SUBDIVISION REPORT - CONCEPT/USE ON REVIEW

▶ **FILE #:** 3-SA-21-C **AGENDA ITEM #:** 21
3-B-21-UR **AGENDA DATE:** 3/11/2021

▶ **SUBDIVISION:** MURPHY ROAD SUBDIVISION
▶ **APPLICANT/DEVELOPER:** JOSH SANDERSON / SOUTHLAND GROUP, INC.
OWNER(S): Southland Group Inc.

SINGLE FAMILY CONCEPT & DEVELOPMENT PLAN FOR
 SOUTHLAND GROUP INC
 CLT MAP 49, PART 02PARCEL 67
 DISTRICT 6, KNOX COUNTY, TENNESSEE

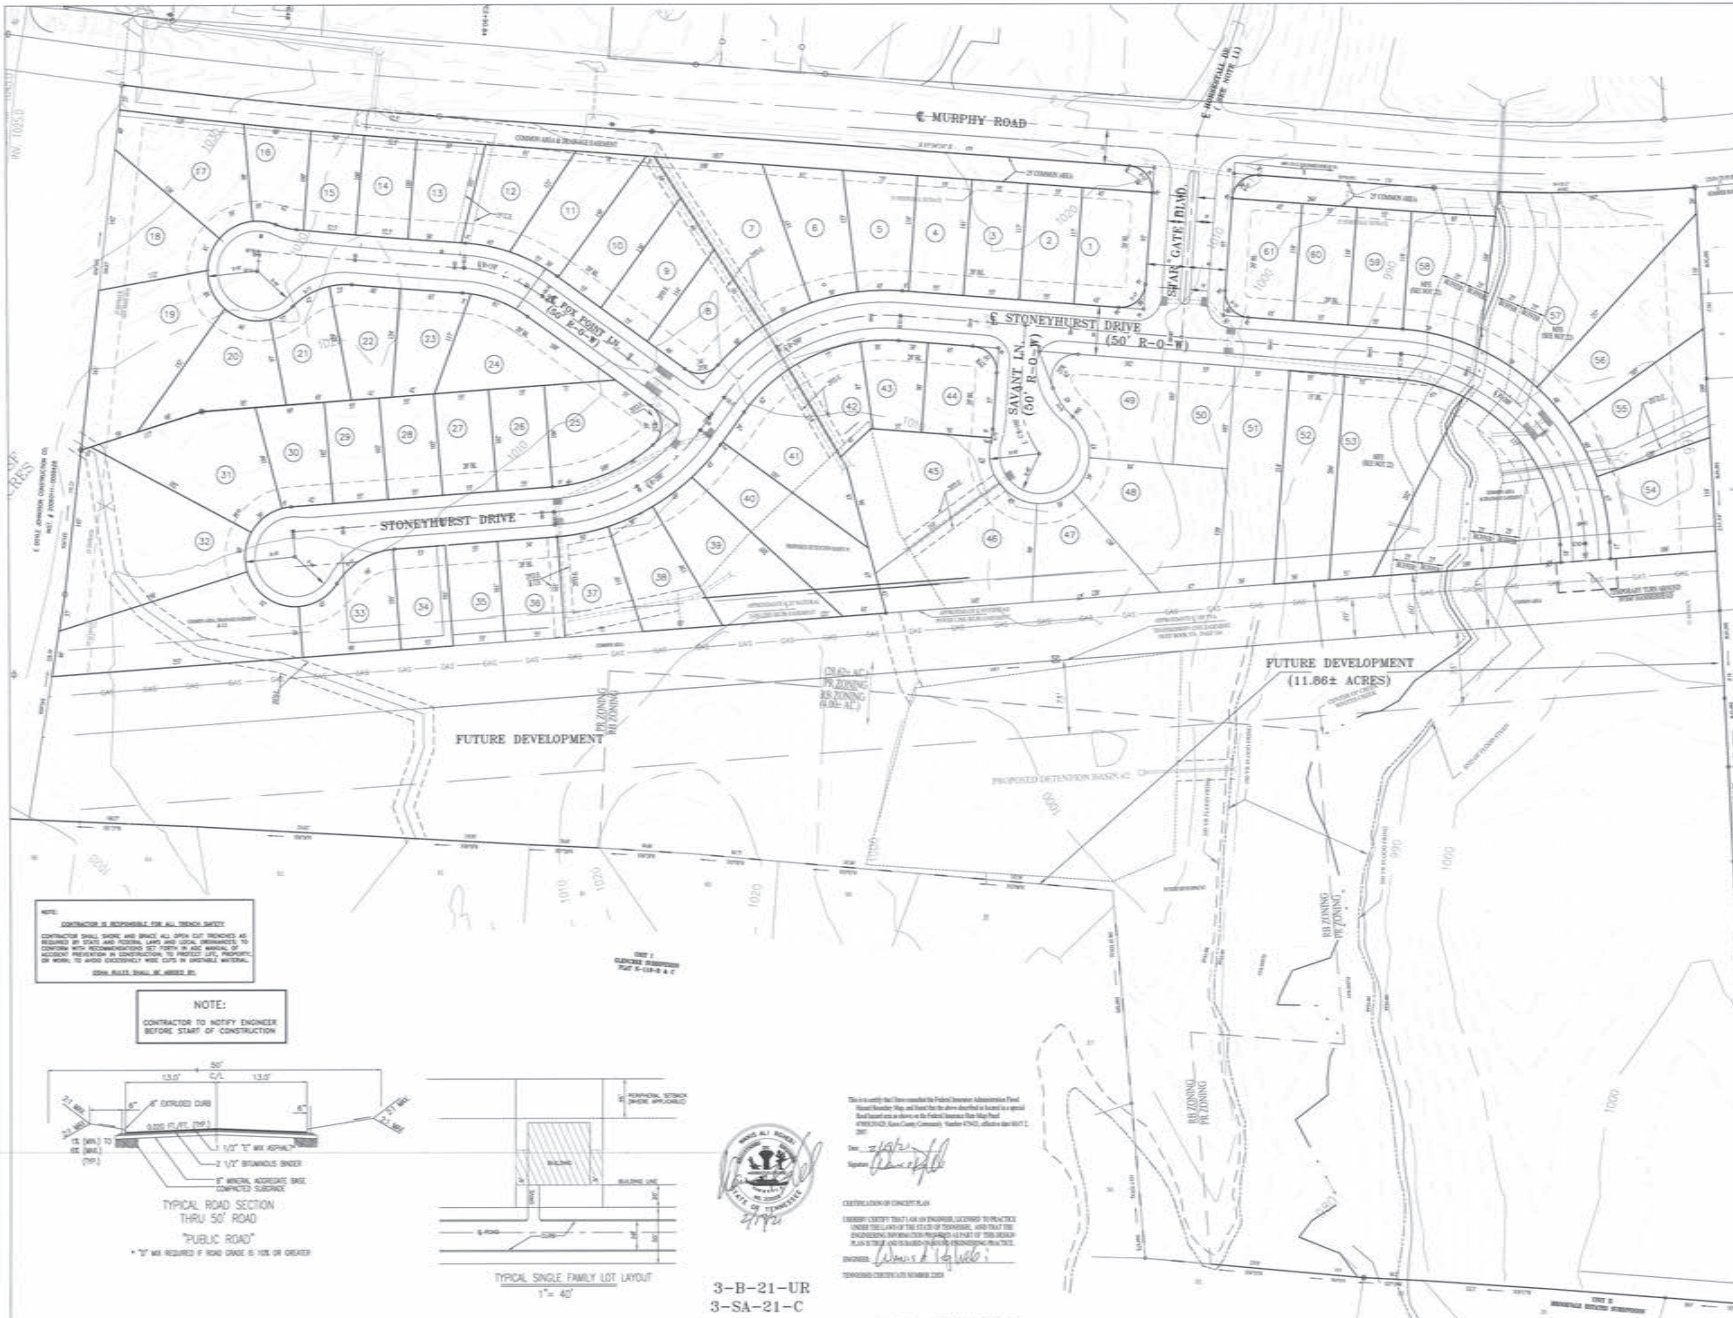
1) REDUCE THE MINIMUM TANGENT FOR THE REVERSE HORIZONTAL CURVE RADIUS ON STONEYHURST DRIVE FROM 50-FT TO 40-FT AT STA 4+85.61 TO 5+26.15 2) REDUCE THE MINIMUM CONNECTING VERTICAL CURVE ON STAR GATE BOULEVARD AT MURPHY ROAD FROM K=25 TO K=15.34

1) REDUCE THE MINIMUM HORIZONTAL CURVE RADIUS ON STONEYHURST DRIVE FROM 250-FT TO 200-FT AT STA 3+12 TO 4+85

2) REDUCE THE MINIMUM HORIZONTAL CURVE RADIUS ON STONEYHURST DRIVE FROM 250-FT TO 200-FT AT STA 5+26 TO 7+29
3) REDUCE THE MINIMUM HORIZONTAL CURVE RADIUS ON STONEYHURST DRIVE FROM 250-FT TO 200-FT AT STA 12+31 TO 15+20

1) INCREASING THE MAXIMUM ROAD GRADE AT INTERSECTIONS FROM 1% TO A MAXIMUM OF 3%

4. Providing a note on the plat that lots 53, 57 & 58 have a minimum finished floor elevation one-foot above the 500-year flood plain as required by Knox County Engineering and Public Works during the design plan phase.

6. Providing a 15' rear setback line on the final plat for all lots that are adjacent to the 25' common area along the Murphy Road frontage.
 7. Providing a 25' common area on the final plat between Murphy Road and any double frontage lot that has an average depth less than 150 feet.

8. Providing a temporary turnaround at the southwest terminus of Stoneyhurst Drive per the requirements of Knox County Engineering and Public Works and the Knox County Fire Prevention Bureau.

9. Providing documentation to Knox County Engineering and Public Works during the design plan phases that lot 58 has sufficient buildable area outside the stream buffer.

- **APPROVE** variances 1-2, and alternative design standards 1-3 on the recommendations of the Knox County Department of Engineering and Public Works, and because the site conditions restrict compliance with the Subdivision Regulations and the proposed variances will not create a traffic hazard.

APPROVE the Concept Plan subject to 13 conditions.
